Accessibility Assessment Report

Project Name: Macarthur Gardens North R3

Type of Mark Up: Advice based on 50% Design Development

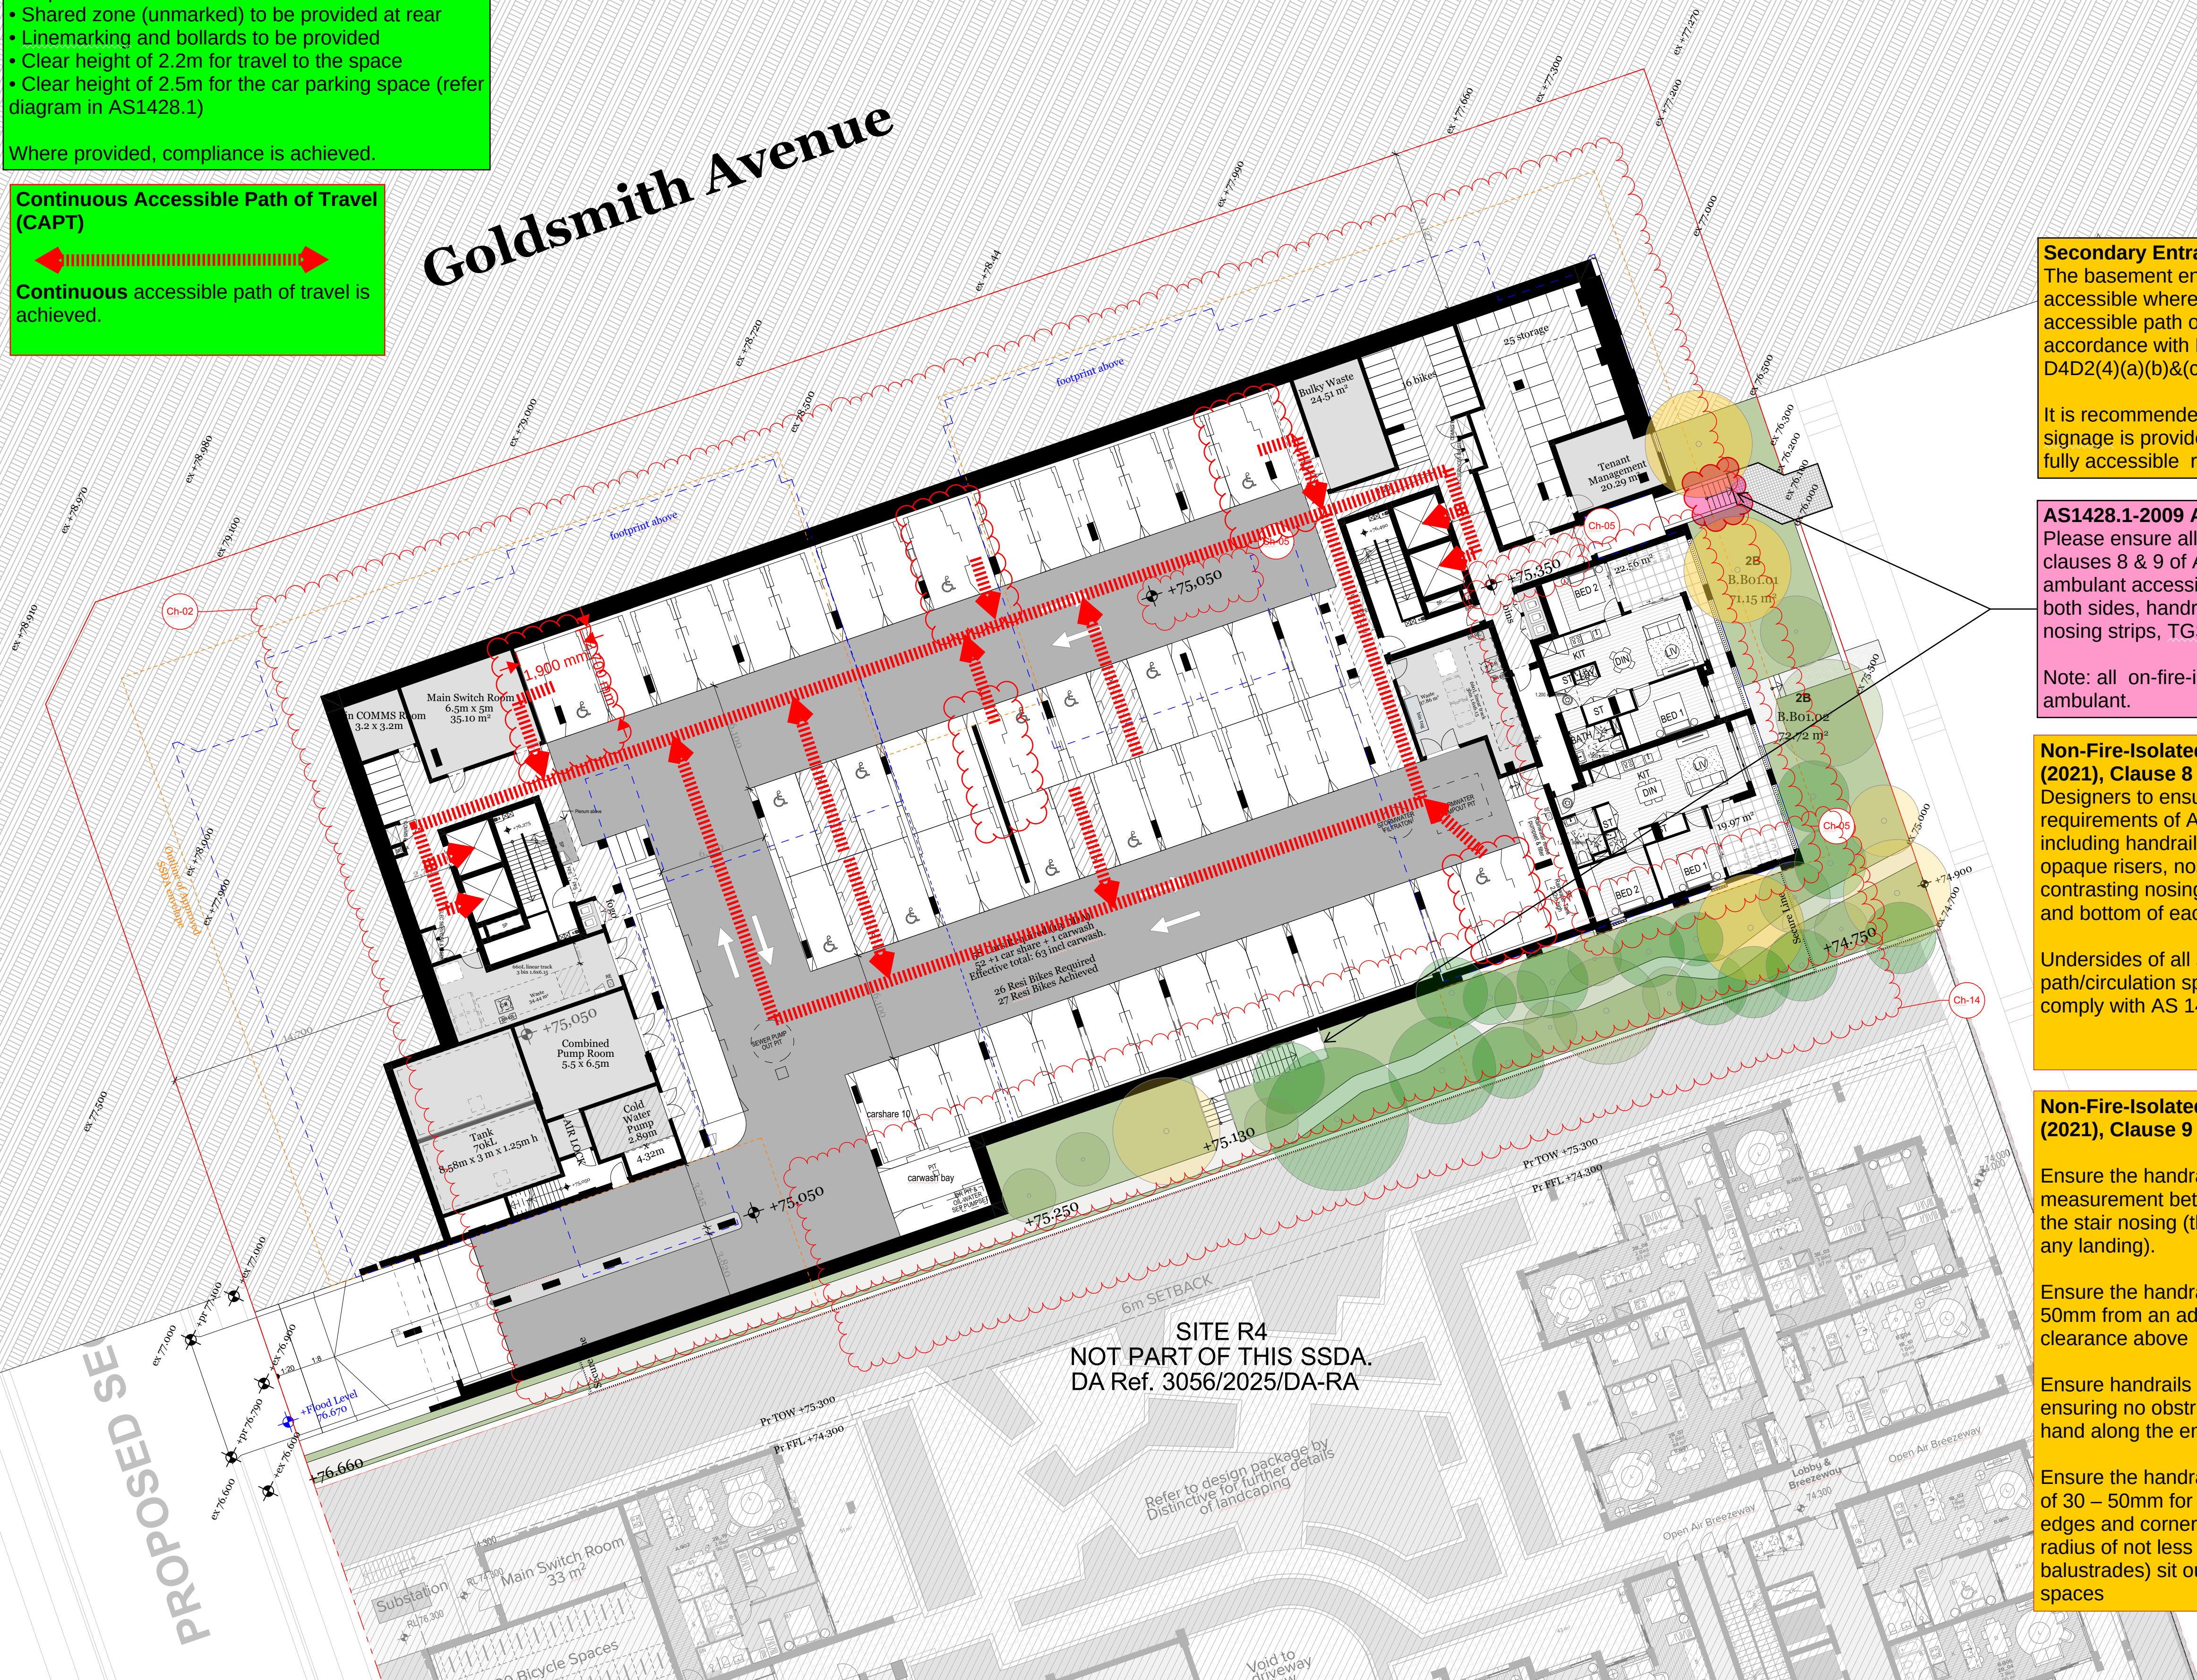
Lift landings - AS 1735.12 (1999), Section 7.3.3
Consideration must be had to the location of the passenger lift control button location.

One side encounters an internal corner with the adjacent balustrade. The opposite side encounters the stair handrail extension.

AS 1735.12 (1999), Section 7.3.3 - *Control buttons shall be located adjacent to the lift entrances and shall not be closer than 500 mm from any internal corner or fixed obstruction.*

Fire Isolated Stairways - AS 1428.1 (2021), Clause 8.1 (d)(e)(f)(g)

Ensure front edges of stairs nosing have a strip with a min. 30% luminance contrast 50 – 75mm wide (full width of path of travel) (can be set back 15mm) (must not project beyond the face of the riser and not extend more than 10mm down the riser when provided with a contrast and not set back from nosing)

Continuous Accessible Path of Travel (CAPT)

Continuous accessible path of travel is achieved.

It is recommended to ensure clear way finding signage is provided indicating an alternative fully accessible route is provided.

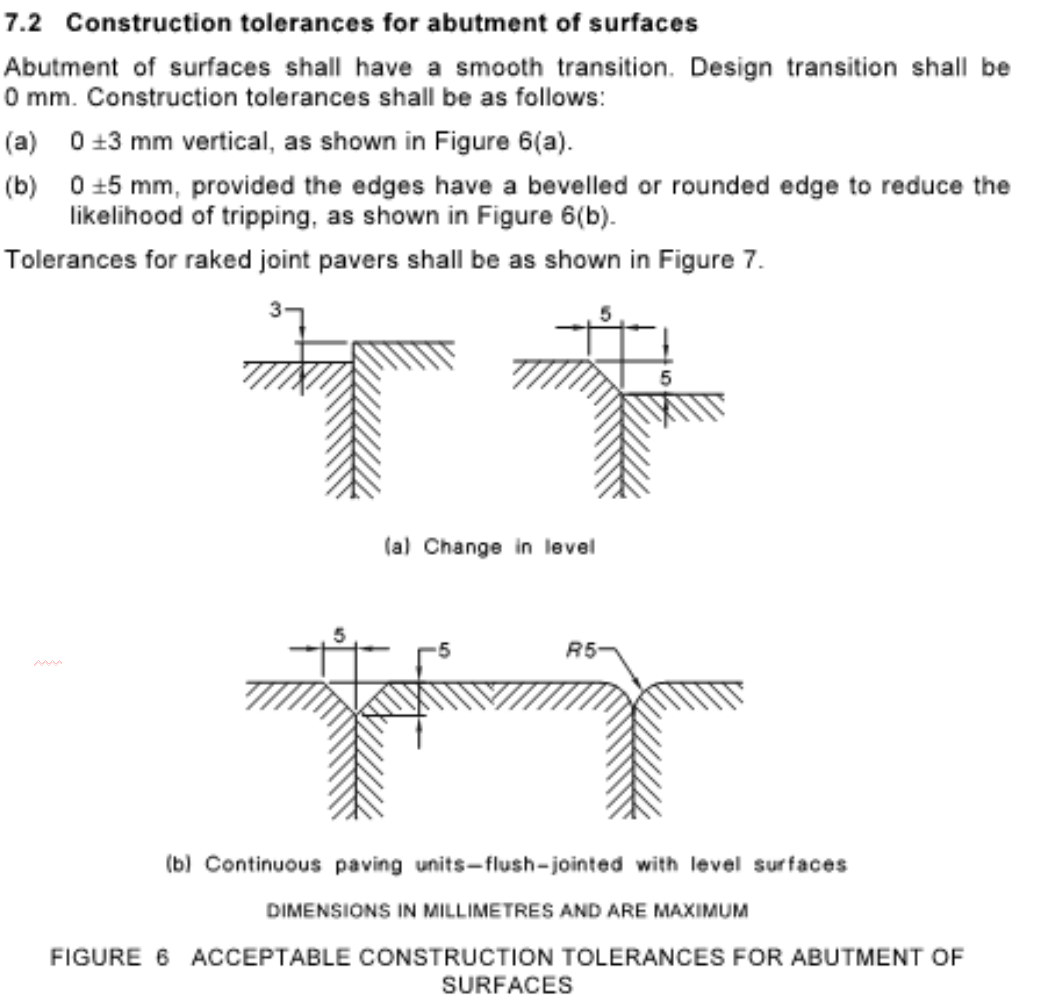
Access to buildings - NCC, Part D4D3 (General)
A continuous accessible path of travel is to be provided to any building required to be accessible from:
(a)
(i) The main points of pedestrian entry at the allotment boundary; and
(ii) From another accessible building connected by a pedestrian link; and
(iii) From any required accessible car parking space on the allotment.
(b)
In a building required to be accessible, an accessway must be provided through the principal pedestrian entrance, and:
(i) Through not less than 50% of all pedestrian entrances including the principal pedestrian entrance; and
(ii) In a building with a total floor area more than 500 square metres, a pedestrian entrance which is not accessible must not be located more than 50m from an accessible pedestrian entrance.

Access is required from allotment boundary to the doorway of each SOU in accordance with AS14281. Door circulation spaces will apply to gates serving common areas and wheelchair turning spaces are required at the common entrance pathway and into the building SOU doorways with 1540mm x 2070mm turning space required.

AS1428.1-2021 Section 4 - Continuous Accessible Path of Travel
Ensure accessible path of travel to and within all areas normally used by occupants to have slip resistant surface. Abutment of surface to have smooth transition; design tolerances to be 0mm with construction tolerances as shown below

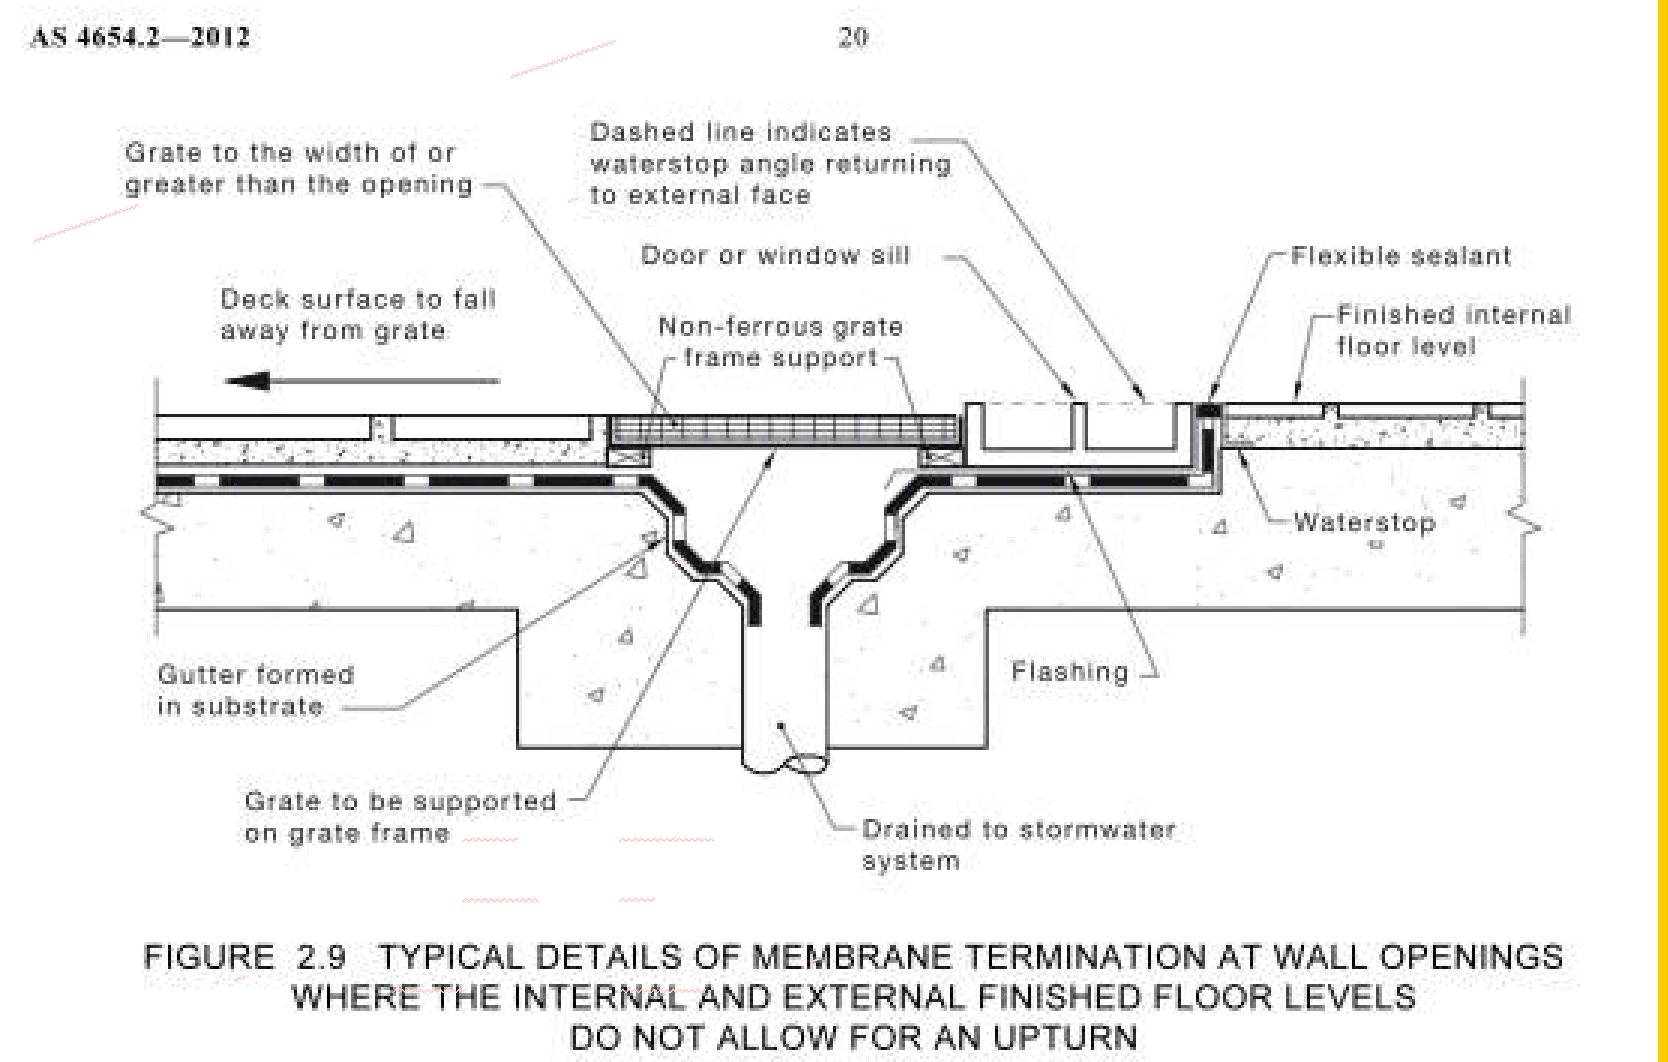
It is recommended to introduce flush thresholds to allow access out to each adaptable unit balcony.

AS4652.2 flush threshold detail is therefore recommended including the installation of a water-stop to abutment between internal floor finish and threshold drain grate as per Figure 2.9 of AS4654.2-2012 - see below

01 PRE-ADAPTABLE
Scale 1:100

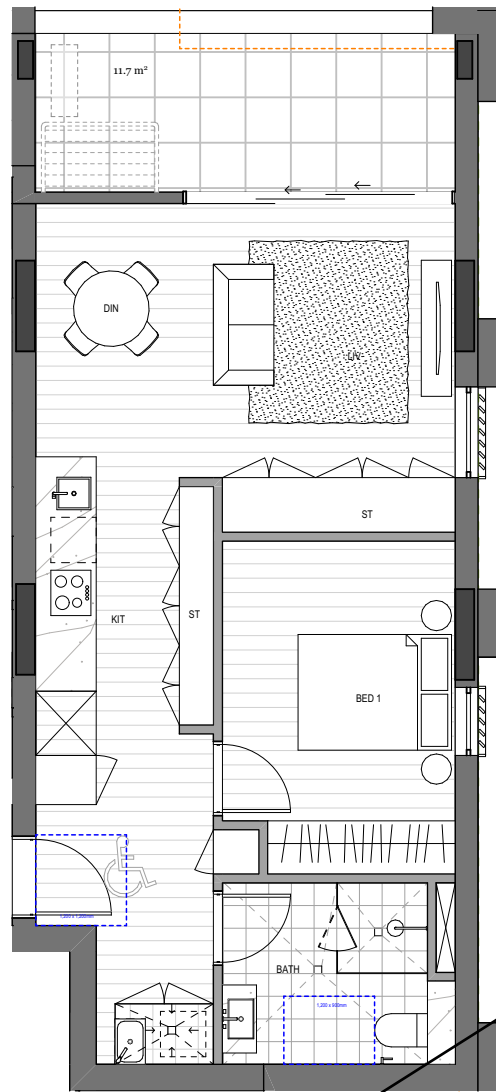
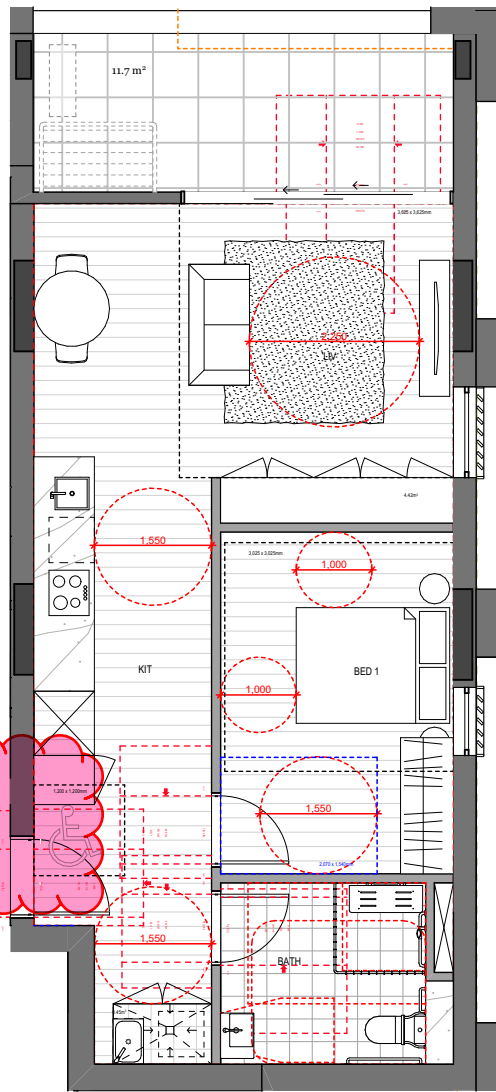
AS4299 Clause 4.3 Entrances, Doorways and Circulation Spaces
Clause 4.3.1 of AS4299 requires the Adaptable Unit Entry door complying with AS1428.2 & AS1428.1 - 850mm clear width opening required.

Clause 4.3.6 of AS4299 requires the door circulation space in accordance with AS1428.1 with minimum latch side clearances to be provided e.g. 530 latch side clearance required as door opens towards user

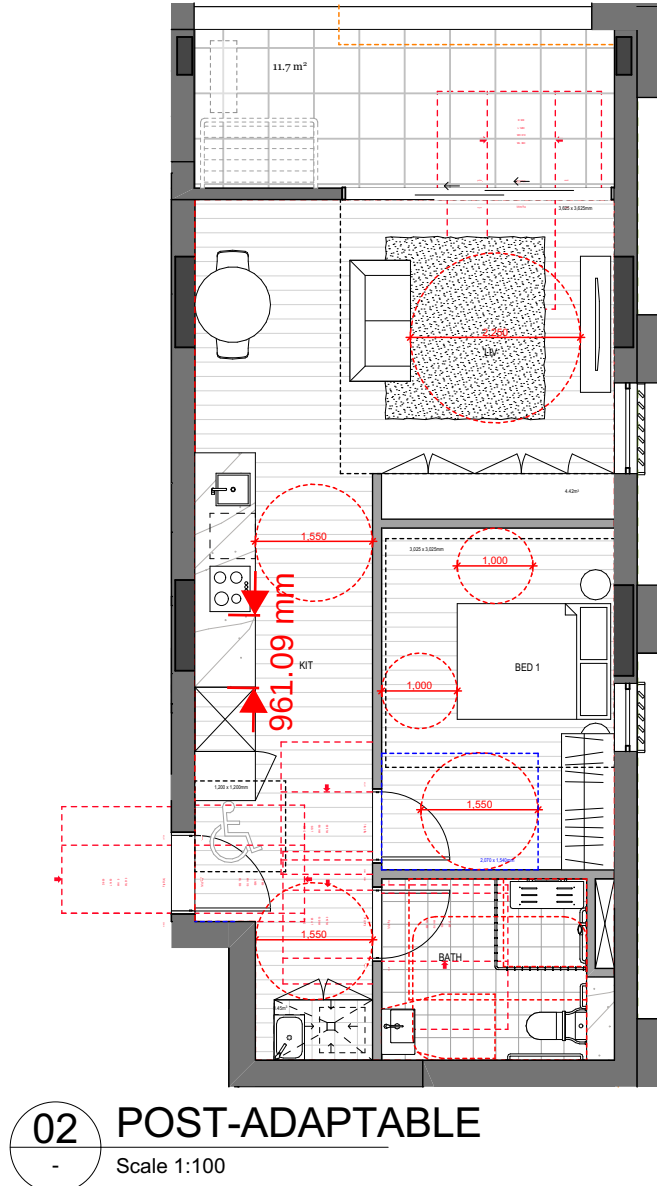
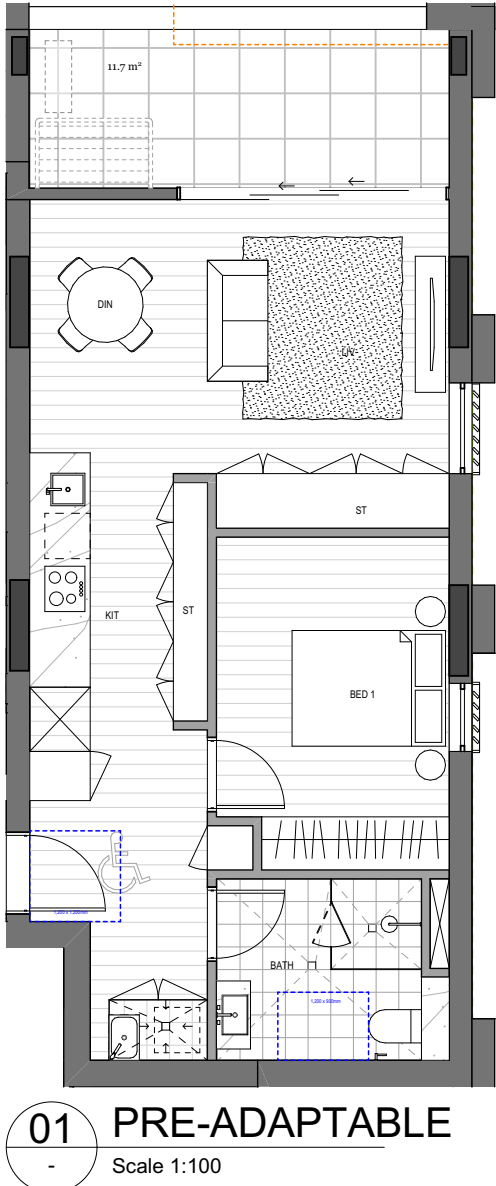
Clause 4.3.7 of AS4299-1995

Internal corridors shall have a minimum width of 1000mm with circulation spaces to comply with AS1428.1
Circulation spaces at doorways shall comply with - AS 1428.1 (2009), Clause 13.3

The current design indicates compliance can be achieved.
